Docket Number:	19-SPPE-02
Project Title:	Walsh Data Center
TN #:	231329
Document Title:	Record of Conversation from Silicon Valley Power – response to questions on 7219 (TN 229077)
Description:	SVP responses to CEC staff questions and historical outages
Filer:	Cenne Jackson
Organization:	California Energy Commission
Submitter Role:	Commission Staff
Submission Date:	12/27/2019 12:09:15 PM
Docketed Date:	12/27/2019

CALIFORNIA ENERGY COMMISSION
REPORT OF CONVERSATION Page 1 of 1

PROJECT TITLE: Laurelwood Data Center **Docket:** 19-SPPE-01

SUBJECT: Siliocon Valley Power (SVP) Responses to Questions from Staff

**LARELINDO SUBSTATION
SINGLE-LINE OVERHEAD**

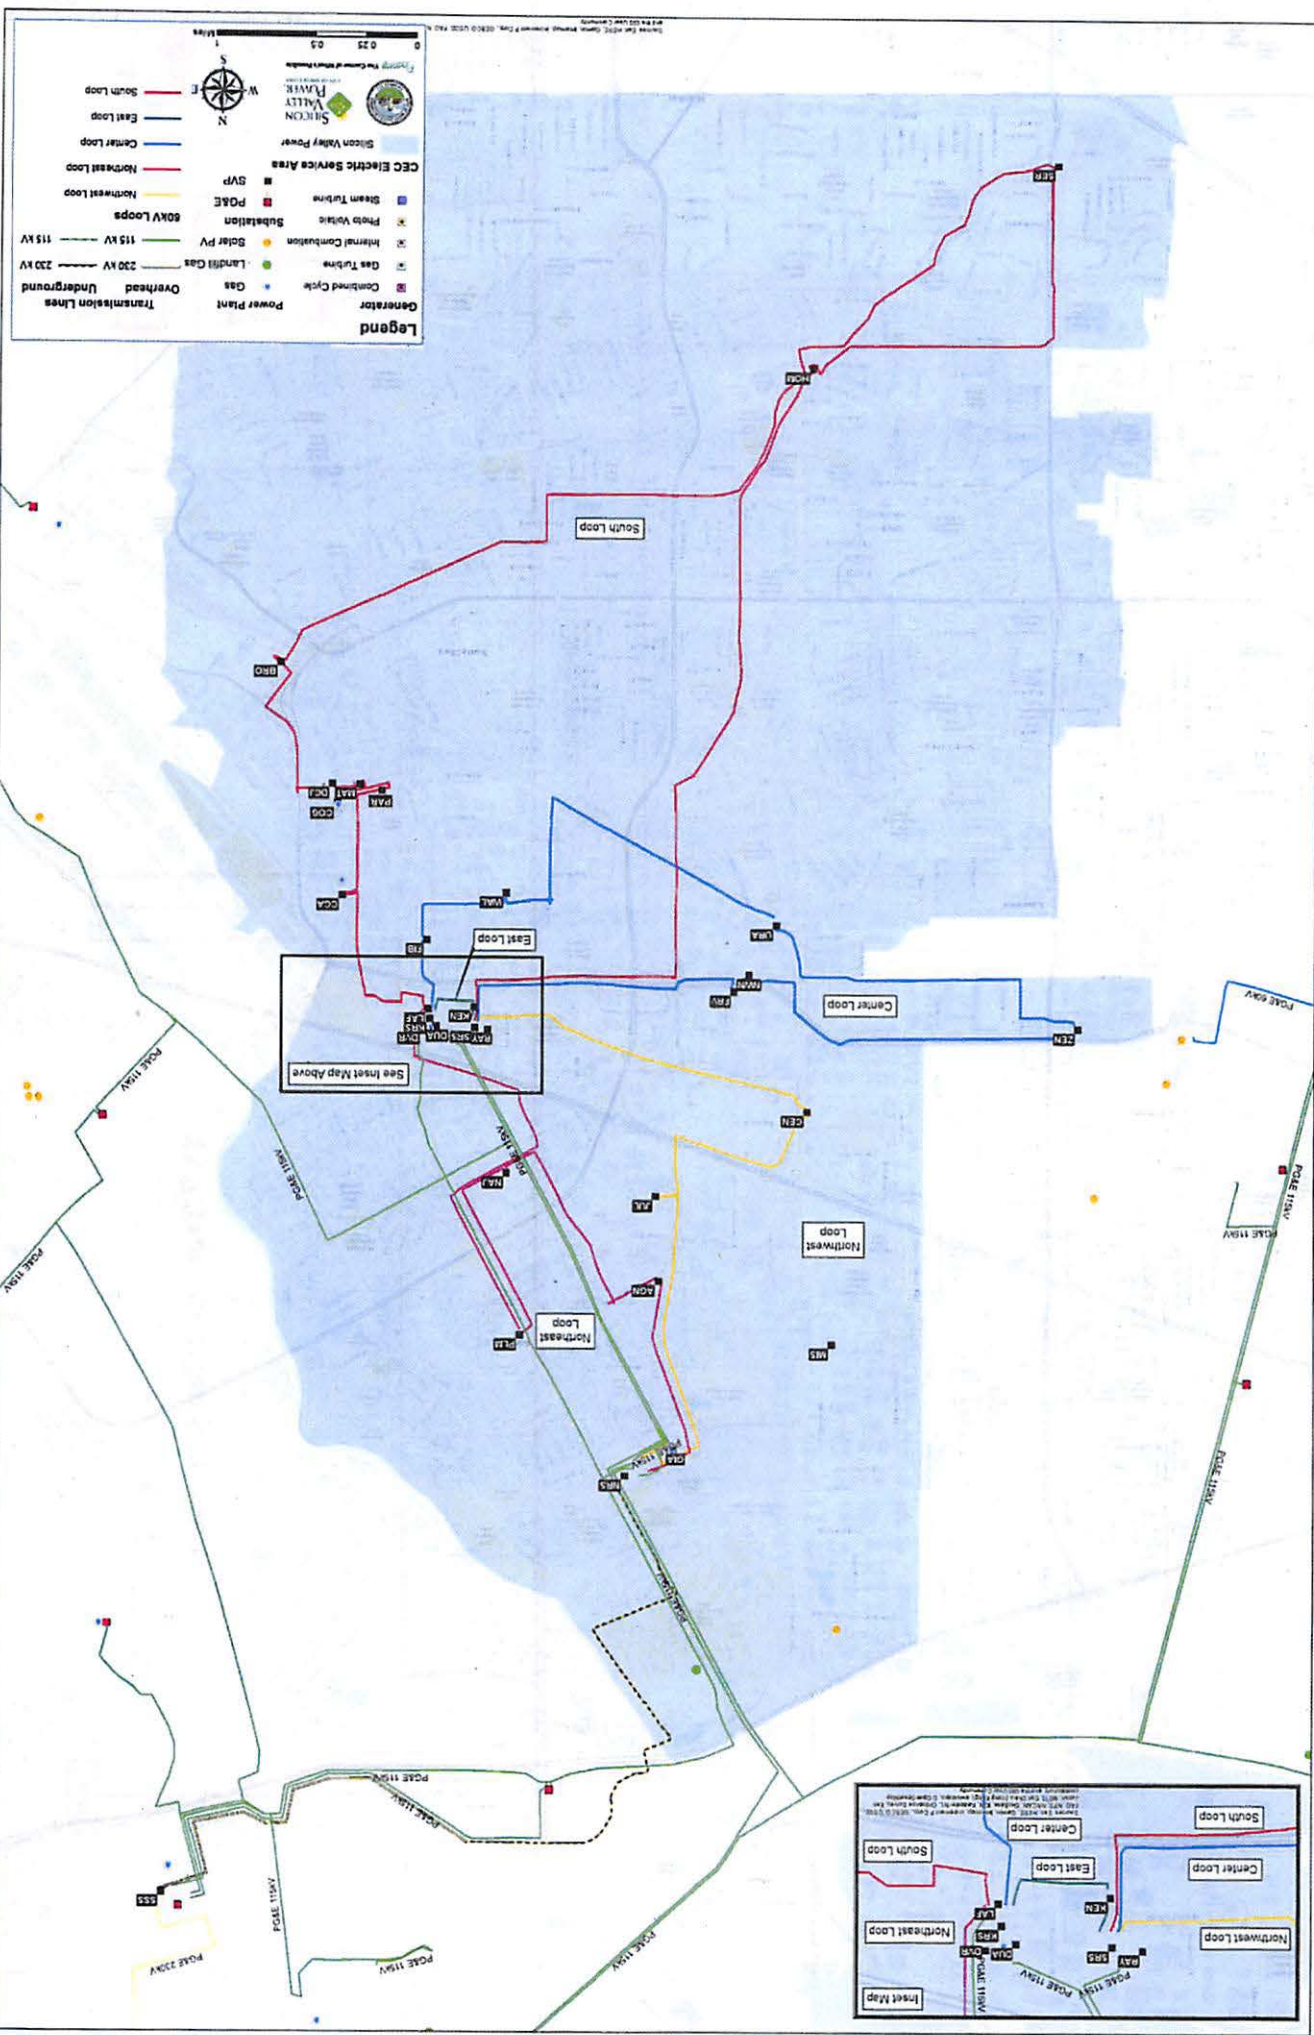
1. Please provide for the 60 kV loop on the SVP system that will serve the Laurelwood data center:

- a. A physical description

- c. The breakers and isolation devices and use protocols

Laurelwood Substation is a three-50MVA (60kV:12kV) transformer bank substation on SVP's 60kv South Loop. It is located between our 115kV Kifer Receiving Station (KRS), and 60kV substation, CCA. Each Transformer has a rating of 30/40/50 MVA, IEEE max temperature rise of 65 C, increases the capability by 10% or 33/44/56 MVA. The final buildout of Laurelwood substation will have a capability of 100 MVA, with 150 MVA of installed capacity which increases its reliability. Laurelwood Substation Single Line Diagram XXX-E-0-X-1 is attached.

There are four 60kV Breakers at Laurelwood, CB12, CB22, CB32 and CB42 which will enable various isolation schemes to insure a transformer bank can be isolated while the other two transformers remain in service. The system is designed such that one of the transformers can be taken out of service for repairs or maintenance while the other two can fully support customer load.

Silicon Valley Power

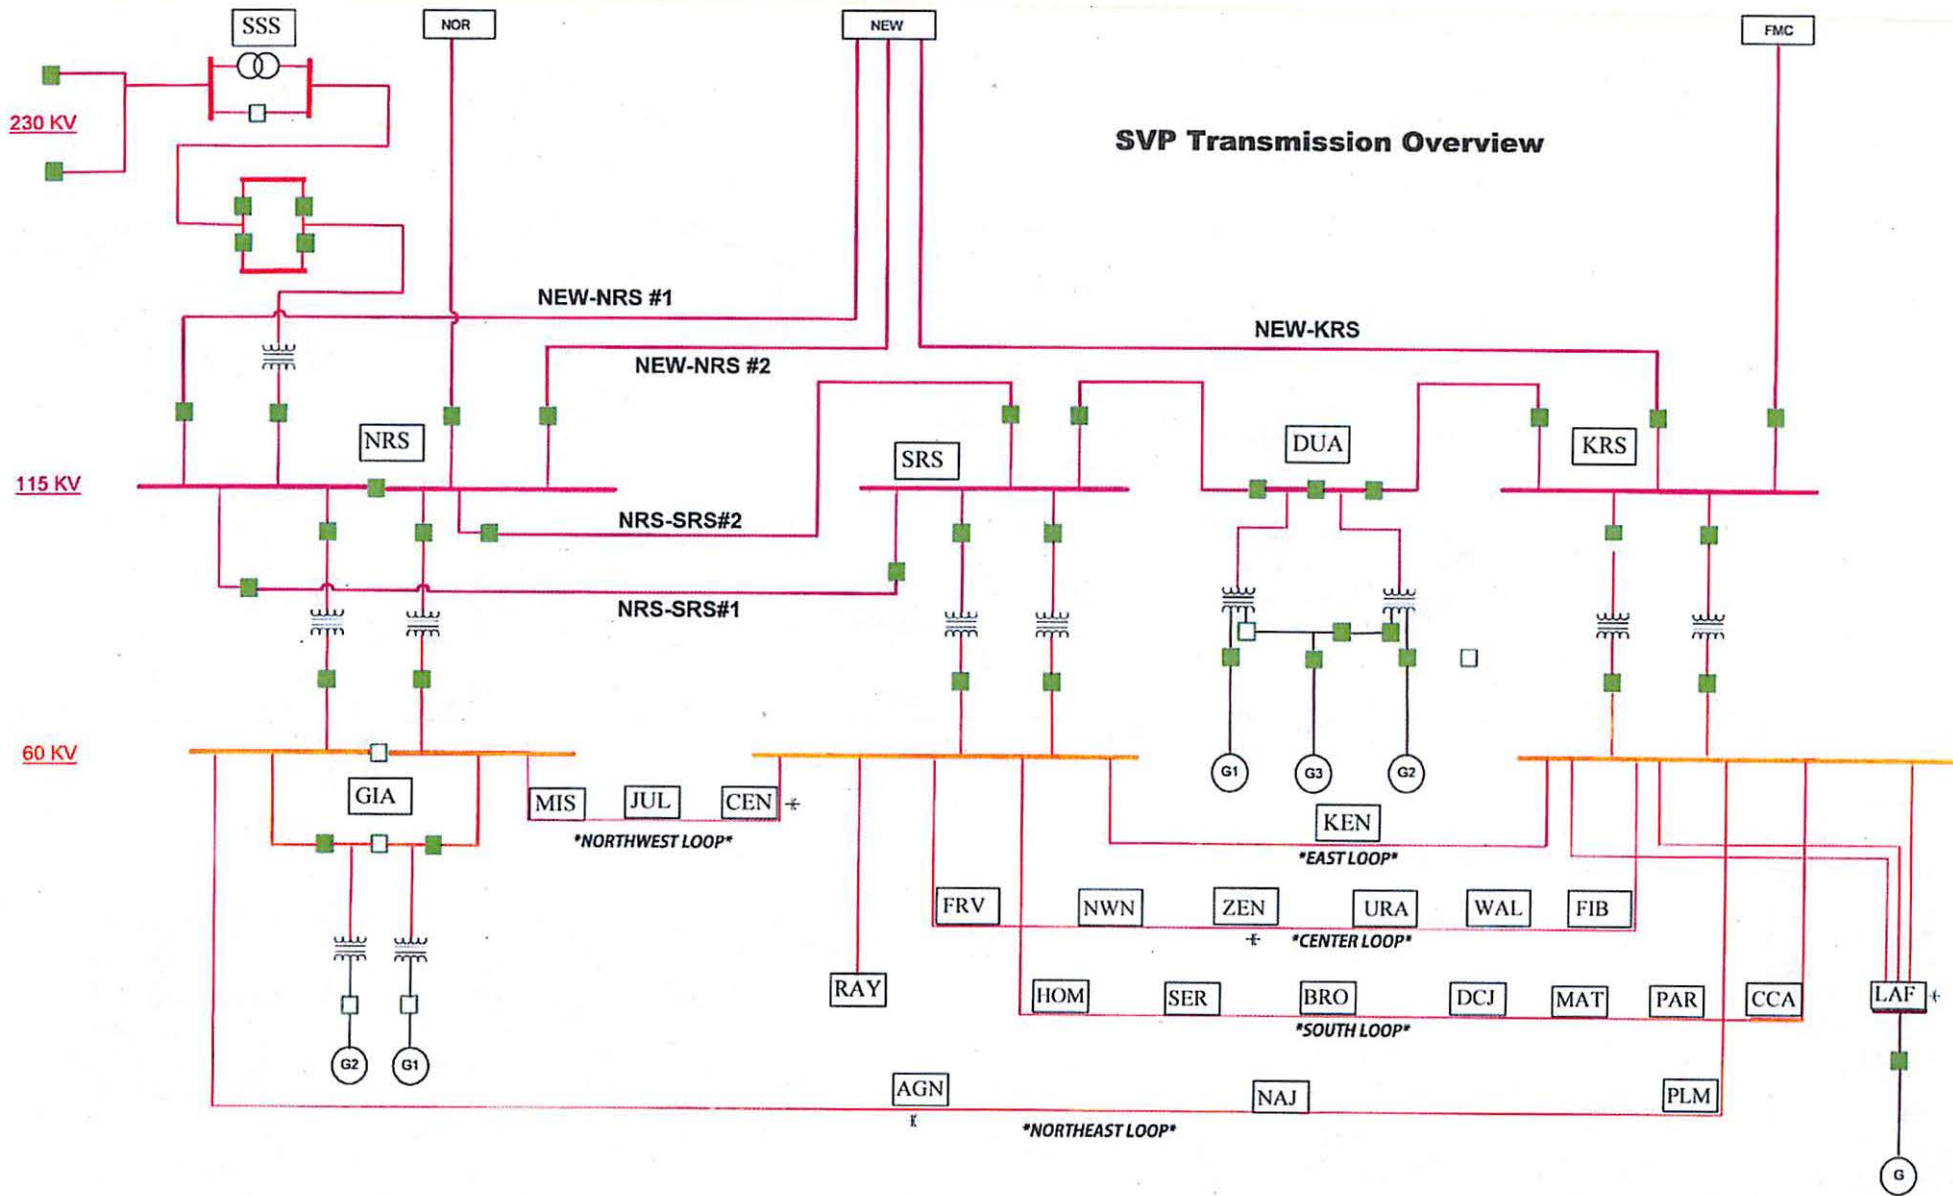
2. Please provide a description of the SVP system in general and the other 60 kV loops that would serve data centers.
 - a. Could you provide a one-line diagram and a "*.shp" file of the 60 kV and above lines serving the Silicon Valley Power System? Would you have any concerns with us using either of these in a public document?

See Attached Diagram SVP CA Energy Map 8-2-19 and the SVP Network Diagram
